ORDER FOR MODIFICATION OF LICENSE

SAFETY EVALUATION BY THE OFFICE OF NUCLEAR REACTOR REGULATION

SUPPORTING AN INTERIM POWER LIMIT OF 90% OF FULL POWER

ST. LUCIE PLANT UNIT NO. 1

FIGURE 2.2.3

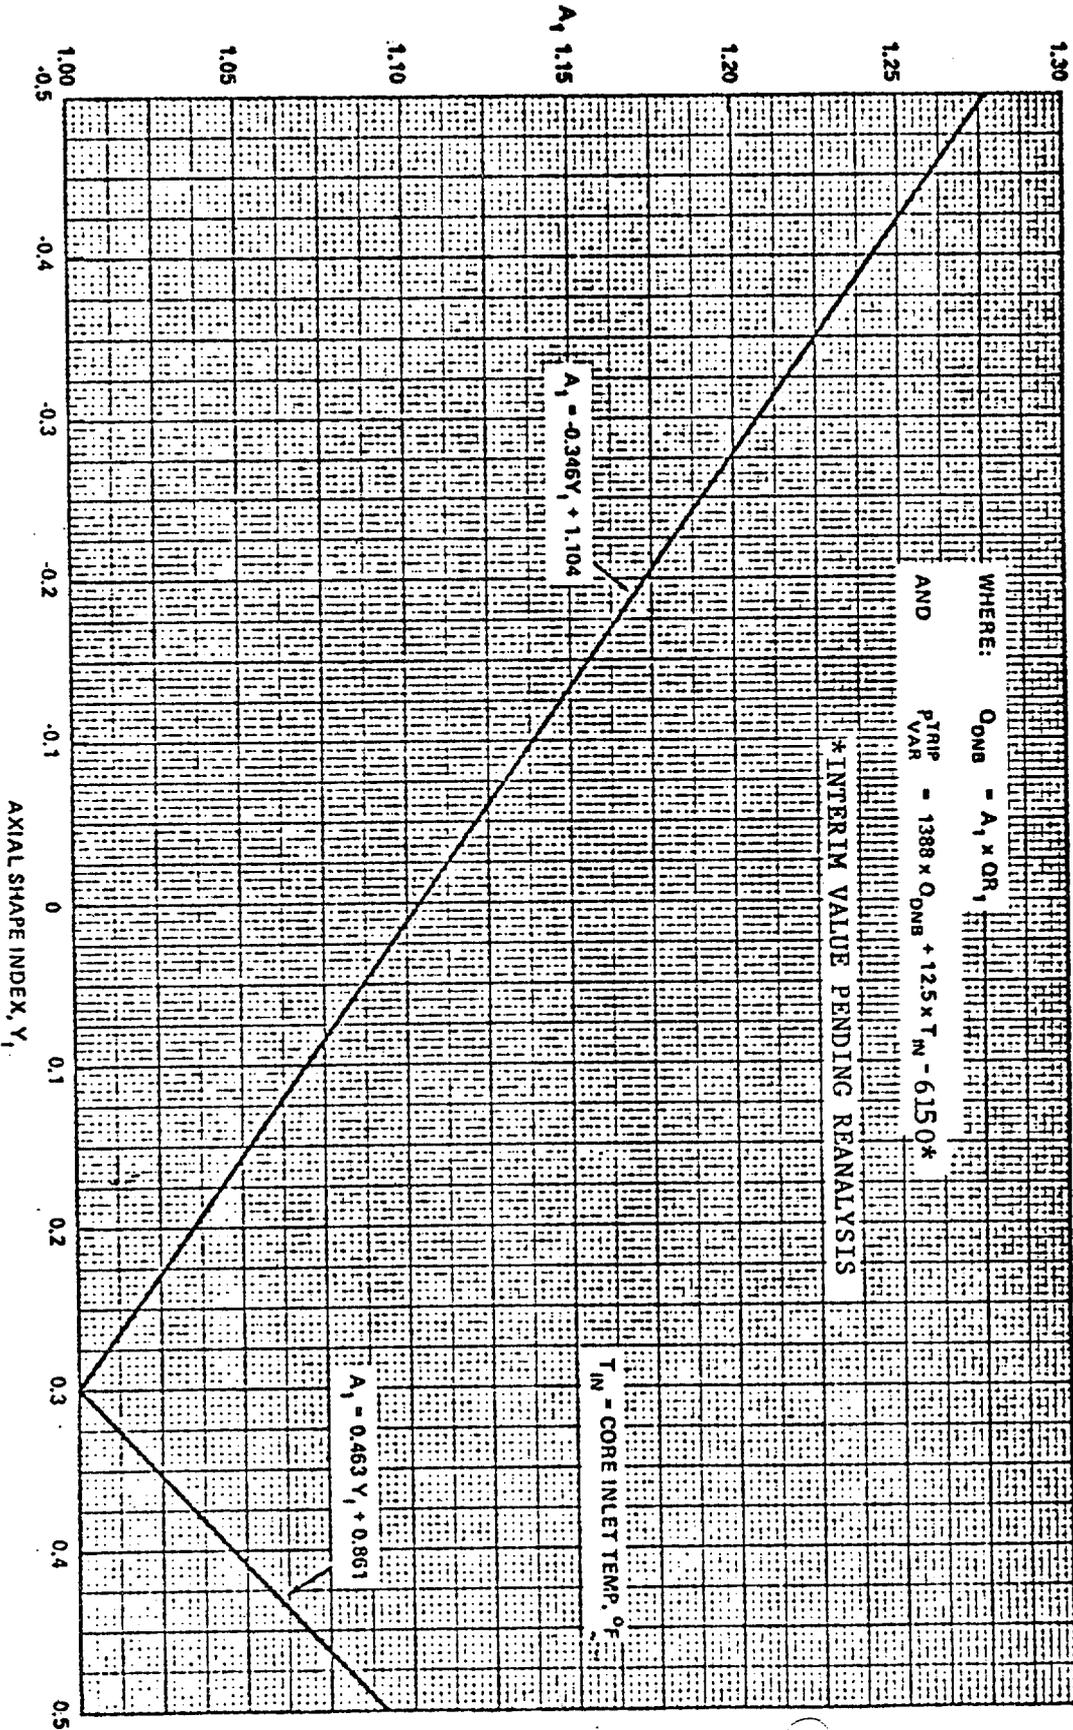
AND $P_{TRIP_VAR} = 1388 \times Q_{DNB} + 125 T_{IN} - 6150^*$

*INTERIM VALUE PENDING REANALYSIS

FIGURE 3.2-4
 AXIAL SHAPE INDEX Operating Limits with 4 Reactor Coolant
 Pumps Operating

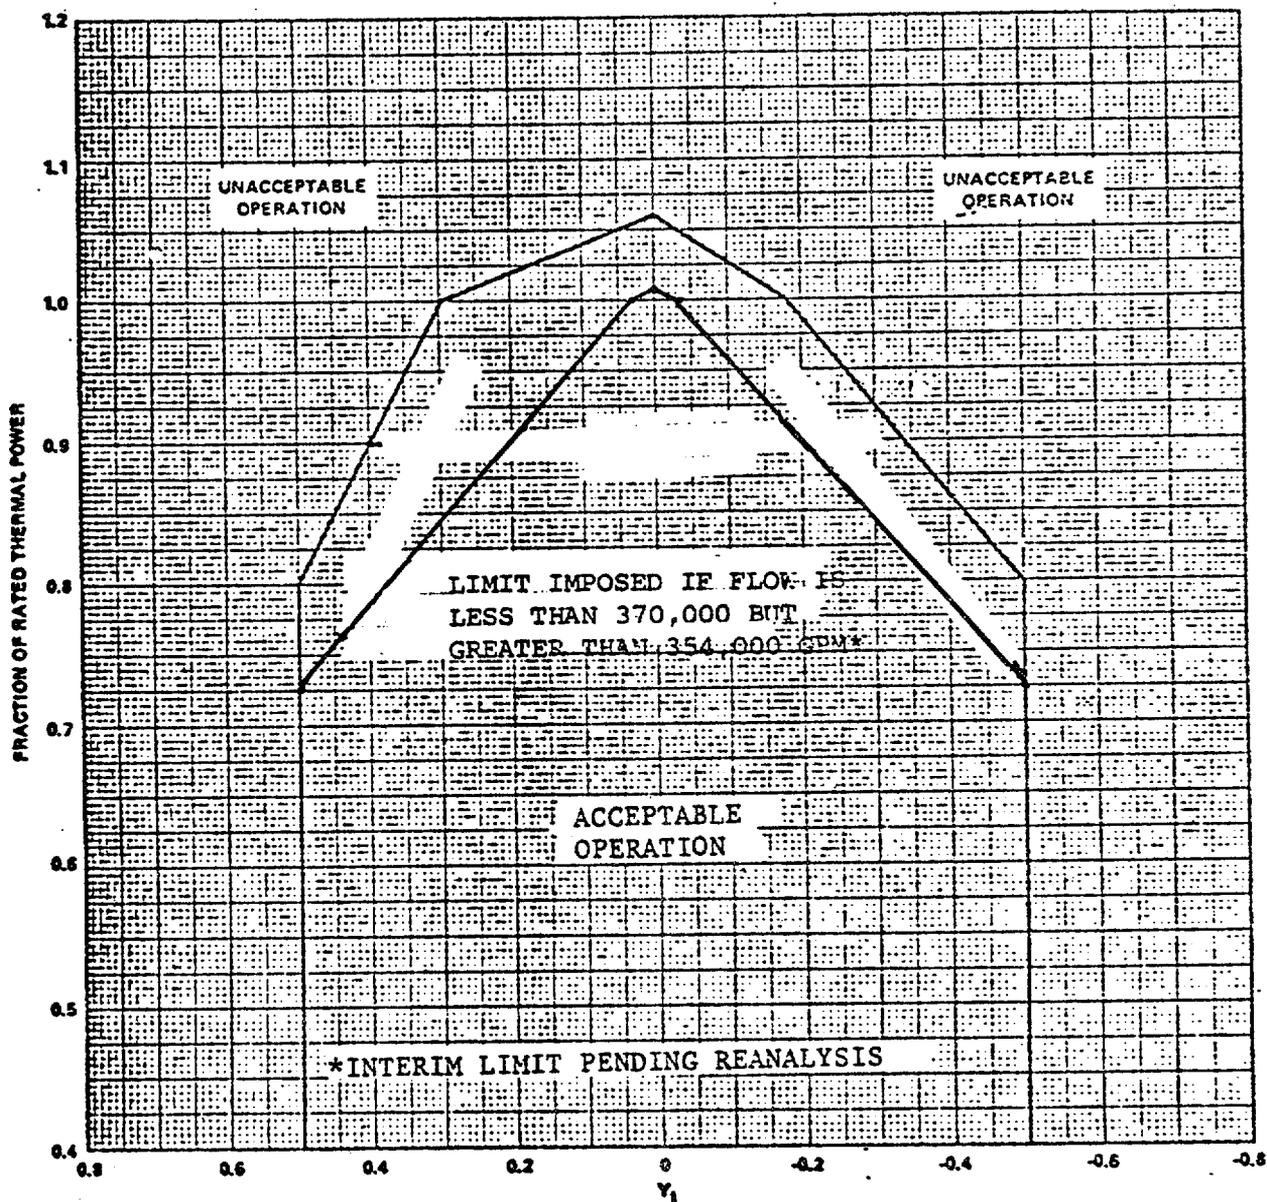
<u>Parameter</u>	<u>Four Reactor Coolant Pumps Operating</u>
Cold Leg Temperature	$\leq 542^{\circ}\text{F}$
Pressurizer Pressure	$\geq 2225 \text{ psia}^*$
Reactor Coolant Flow Rate	$\geq 354,000 \text{ gpm}^{**}$
AXIAL SHAPE INDEX	Figure 3.2-4

**Interim value pending reanalysis.
